Summary of feedback on Pt Chevalier to Westmere cycling and walking improvements

Part 1: Key themes

Meola Road and Garnet Road intersection: subthemes

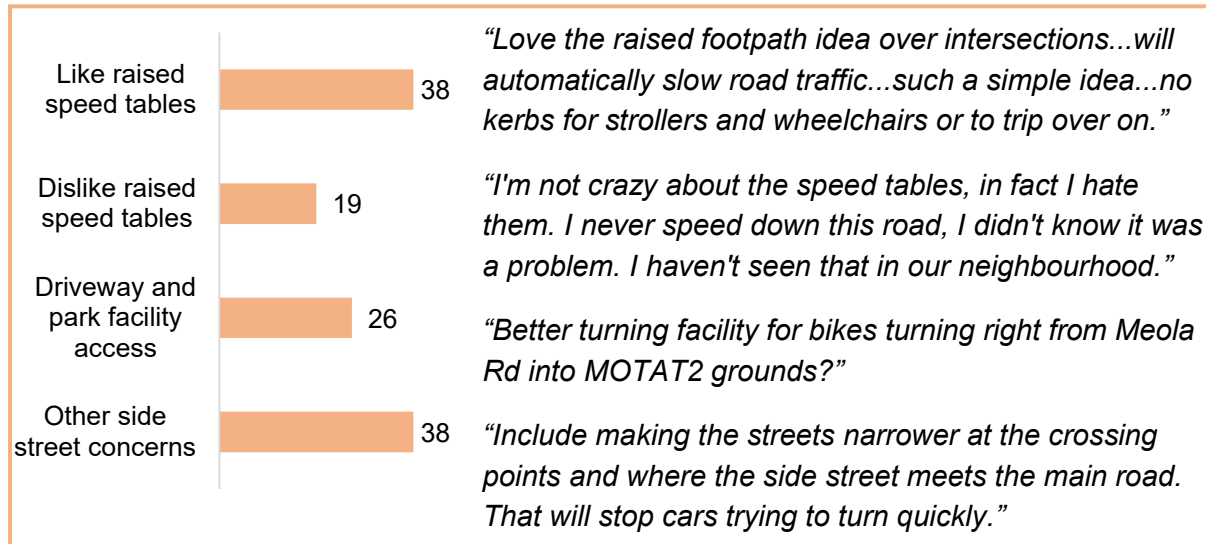
While 17 submitters like the proposed changes, around half of people who commented on this intersection do not like the design (73 submitters). In particular, they are concerned about the reduction of lanes entering the roundabout at the Garnet Road entrances. Other comments included queries on how the roundabout would work for people on bikes and suggestions to slow traffic or install additional pedestrian crossings.

The existing roundabout is a substandard dual lane roundabout. It currently operates as an informal single lane roundabout because the two-lane entries on Garnet Road are not full width lanes, meaning that large vehicles, including buses, currently take up both lanes when turning.

The proposed roundabout redesign will significantly improve pedestrian and cyclist safety, including for local residents accessing the shops and children going to and from Westmere School, by reducing the number of vehicle lanes they need to cross. The proposed single lane entries and kerb build-outs will also slow vehicles approaching the roundabout. The main traffic flow between Meola Road and Garnet Road is expected to operate at an acceptable level of service.

Slower traffic will make it safer for people on bikes who choose to use the road. Less confident people on bikes can use the shared paths to move around the roundabout.

Please note that the proposal includes **red surfacing flush with the road height** at the Garnet Road south and Meola Road access points, not raised tables as were shown in the consultation materials. Raised tables have been discounted, as they are difficult for buses to cross so would not be appropriate here. See [Attachment 1](#) for an amended diagram of the proposed changes.
